**Planning Application Reference SD21A/0106**

**Planning Application: Demolition of existing child care facility; construction of 2 semi-detached, 3-bed residential units and the reinstatement of existing building back to former 3 bed residential unit; carparking, landscaping and all associated site works.**

**Location: 147, Monalea Grove, Dublin 24**

Location Map Boundary

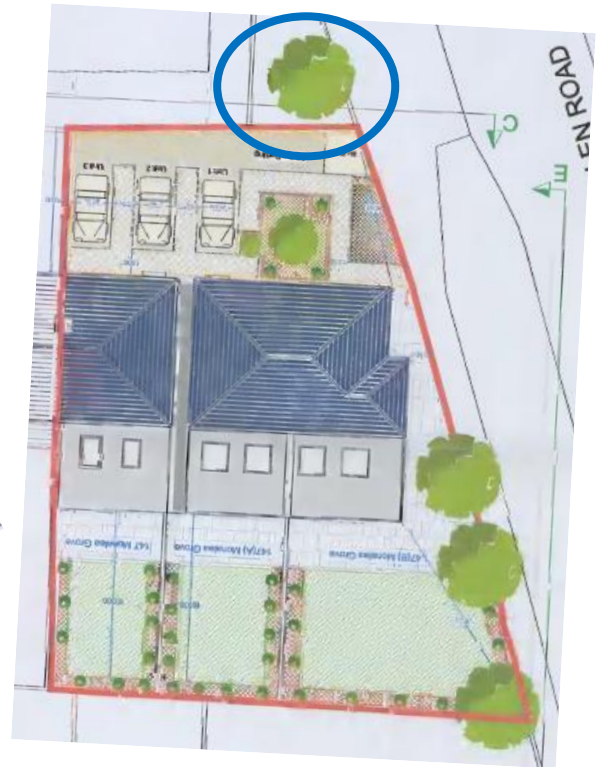
As illustrated in the extracts below, the northern boundary on the layout plan, however, is not consistent with the northern boundary on the location map and includes a section of an existing area of open space. Part of a proposed bin store and area of visitor parking that widens towards the eastern boundary of the layout plan is outside the boundary on the location map. This would take place within an area that is not zoned for residential development under the South Dublin County Council Development Plan 2016 – 2022.

- Submit revised layout and location maps that are consistent in terms of the boundaries for the application site;
- Clarify whether it is intended to encroach into the adjacent area of open space and, if so:
  - demonstrate compliance with the zoning objectives of the County Development Plan; and
  - submit a letter of consent from the landowner.

1. Restricts the proposed development to the boundary indicated on the location map and prohibits any development encroaching on or taking place in the triangular area of open space adjacent to the northern boundary of the application site.

**Photograph of Adjacent Area of Open Space Including Planting (April 2021)**

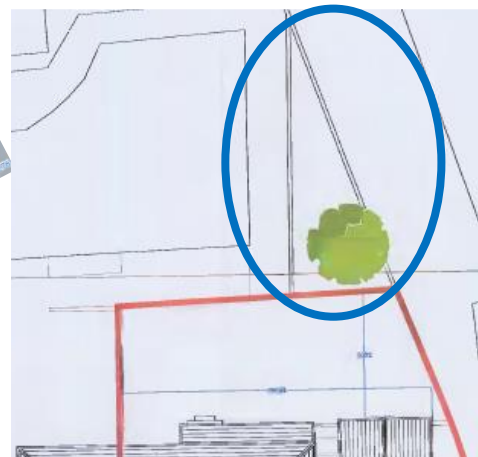
The existing layout plan submitted with the application indicates that the adjacent triangular area of open space is occupied by one sole street tree. As indicated in the images below, this area is occupied by a mature native beech hedgerow, a group of semi-mature native birch trees, an immature birch tree and a street light.

The proposed layout plan seeks to locate a bin store and an area of visitor parking that widens towards the eastern boundary of the application site. The footprint of this aspect of development would require the removal of a section of the mature hedgerow, a mature street tree as well as an immature street tree.

The proposed layout plan is also silent on how the proposed development would interface with the remainder of this area in terms of boundary treatment etc, which would likely affect the health and viability of a further section of mature hedgerow and another semi-mature street tree, particularly during construction.

- a revised layout plan that clarifies and details the relationship between the proposed development and adjacent mature hedgerow, group of semi-mature street trees and immature street tree. This should include details of proposed boundary treatment and should identify planting including street trees and hedgerow that the applicants propose to remove; and
- a construction method statement and plan for the protection of the adjacent mature hedgerow, group of semi-mature street trees and immature street tree.

2. Prohibits the removal of any planting from the triangular area of open space adjacent to the northern boundary of the application site (as indicated on the location map).
3. Requires the applicants to lodge method statements and tree bonds for the protection of the adjacent mature hedgerow, group of semi-mature street trees and immature street tree. A bond should also be required for the protection of the street light.
